Access Compliance Report

Public Rights-of-Way

(Curb Ramps)

Intersection ID: 30157	Main Street: HARLAND_ST	Cross Street: OLD_PLANK_RD	Location: SE
ADA ID: 4B9943BCC27B	Ramp Type: Perp	Initial Pass/Fail: Pass	Overall Compliance: No
		Severity Score: 10

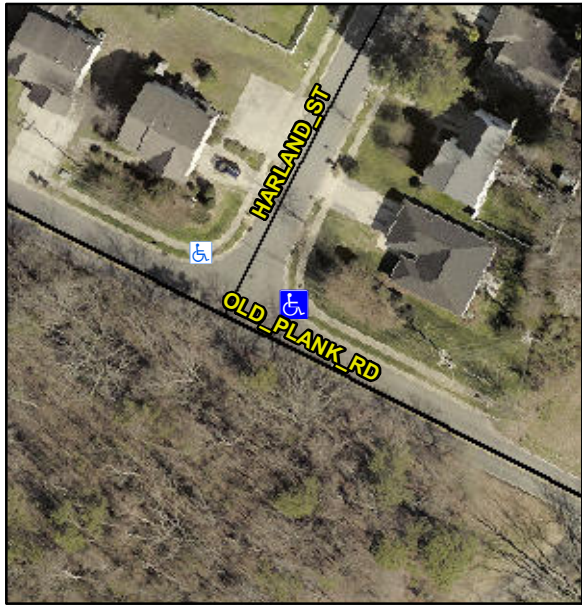
Codes/Mitigation Info/Possible Solution			Field Measurements/Component Compliance							
	Possible Solutions:		Compliance			Description			Data	
	Remove & Replace Entire Ramp.		N/A	Ramp Length (in)	95.5	Yes	Ramp Slope (%)	7.7		
			Yes	Ramp Width (in)	97.0	Yes	Ramp XSlope (%)	0.0		
			N/A	Flare Type LT	Sloped	N/A	Flare Type RT	N/A		
			N/A	Flare Slope LT (%)	4.3	Yes	Flare Slope RT (%)	3.2		
			N/A	Flare Traversable LT?	Yes	N/A	Flare Traversable RT?	Yes		
			No	Landing Length (in)	N/A	Yes	DWS Provided?	Yes		
			No	Landing Width (in)	N/A	Yes	DWS Contrast?	Yes		
			No	Landing Slope (%)	N/A	Yes	DWS Length (in)	24.0		
			No	Landing X Slope (%)	N/A	Yes	DWS Full Width?	Yes		
Surveyor Notes:		N/A	N/A	Landing Curb? (Y/N)	No	No	DWS Offset (in)	6.0		
PROW/ADA:		R304.2.1, R304.2.2-Perp, R304.3.2-Para, R304.5.3, R305.2	N/A	Shared Landing?	No					
			Yes	Gutter Ponding?	No	Yes	Gutter Slope (%)	3.7		
			Yes	Gutter Lip Ht (in)	0.0	Yes	Gutter X Slope (%)	0.4
